January 10, 2020

TO: Planning Commission Members

FROM: Jillian Dierks, Planner, Department of Building & Planning

SUBJECT: PRELIMINARY LAND DEVELOPMENT PLAN – 396 W. Lancaster Avenue, Haverford, Chase Bank, Ward 4, LD# 3845.

Future Turn Lane Concept

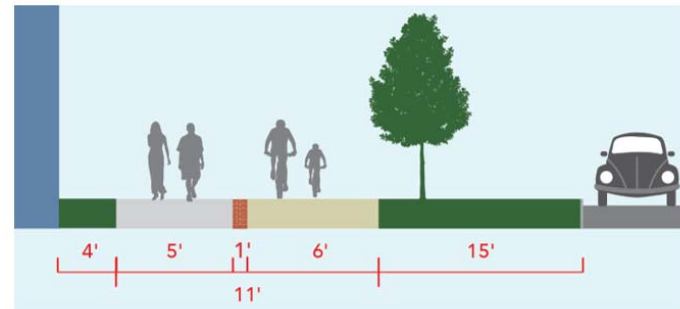
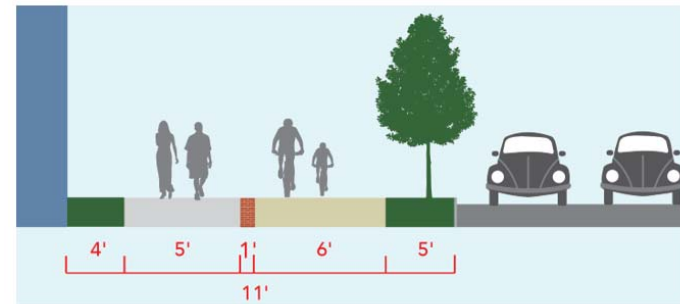
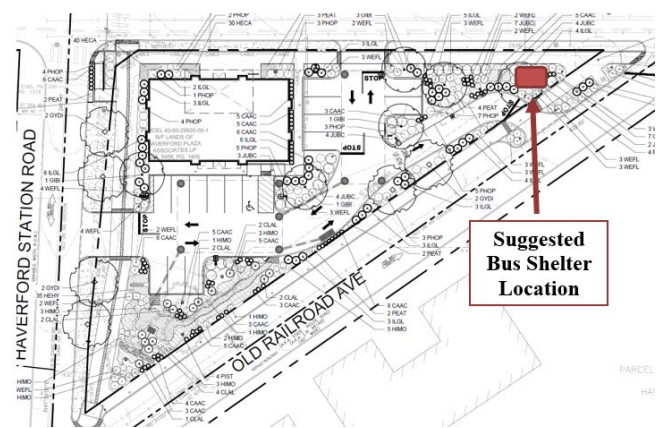
Vehicular: The Planning Commission should be aware that PennDOT has plans to install left turn lanes on all four approaches at the Lancaster Avenue and Haverford Station Road intersection adjacent to this site. Although the time line for PennDOT constructing the lanes has not been released, the construction will likely occur after the new bank is complete. Therefore, staff felt it was important to consider the roadway improvements in the design of the site.

In his review, the Township Engineer recommended that additional right of way be offered on Lancaster Avenue and Haverford Station Road to enable the future left-turn lanes to be constructed. This is requested due to the poor level of service at the northbound Haverford Station approach. With this project, the applicant has only agreed to provide additional right of way on Haverford Station Road. Staff notes that the additional right of way needed on Lancaster Avenue may be acquired by PennDOT at a future date.

Bicycle: Residents reached out to staff with an interest in facilitating a safer bicycle connection through the commercial district from Haverford College to the Haverford Train Station and Bryn Mawr College. Staff supported the inclusion of multi-modal transportation elements and worked with the applicant and the Traffic Safety Unit of the Lower Merion Police Department to include a multi-purpose path adjacent to the public sidewalk along Haverford Station Road. The paved area along Haverford Station Road is 11 feet wide which contains a six-foot path and a four-foot-wide sidewalk which are separated by a one foot wide stamped concrete strip.

Proposed with pyramidal roof.

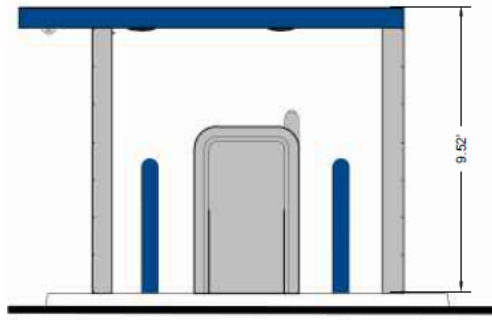
Pyramidal Roof: The front elevation of the building shows a pyramidal roof above the entry way. This feature appears to be purely decorative. Staff feels that the appearance of the building would be improved by removing this portion of the roof and has provided an illustration below.

Staff rendering with pyramidal roof removed.
